SUBJECT: Seabrook License Amendment Request on Concrete Degradation

By letter dated August 1, 2016 (ADAMS [ML16216A250](#)), NextEra Energy Seabrook LLC (NextEra) submitted a license amendment request seeking Nuclear Regulatory Commission (NRC) approval of proposed revisions to the current licensing basis for concrete degradation due to alkali-silica reactor (ASR).

UCS Comments on the ASR License Amendment Request

Figure 1: Map of Seabrook Site Showing Buildings Monitored for ASR Degradation

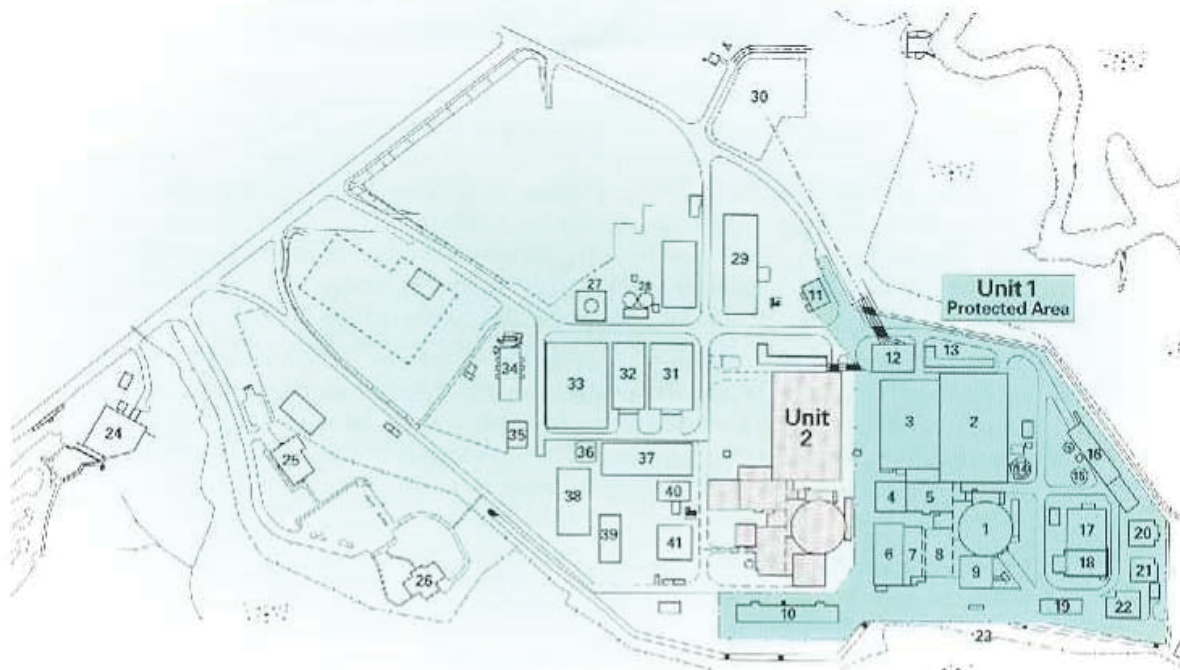
As Figure 1 shows, virtually all the buildings within the protected area for Unit 1 is susceptible to ASR degradation. It is far from a problem confined to only affecting one wall in one building.
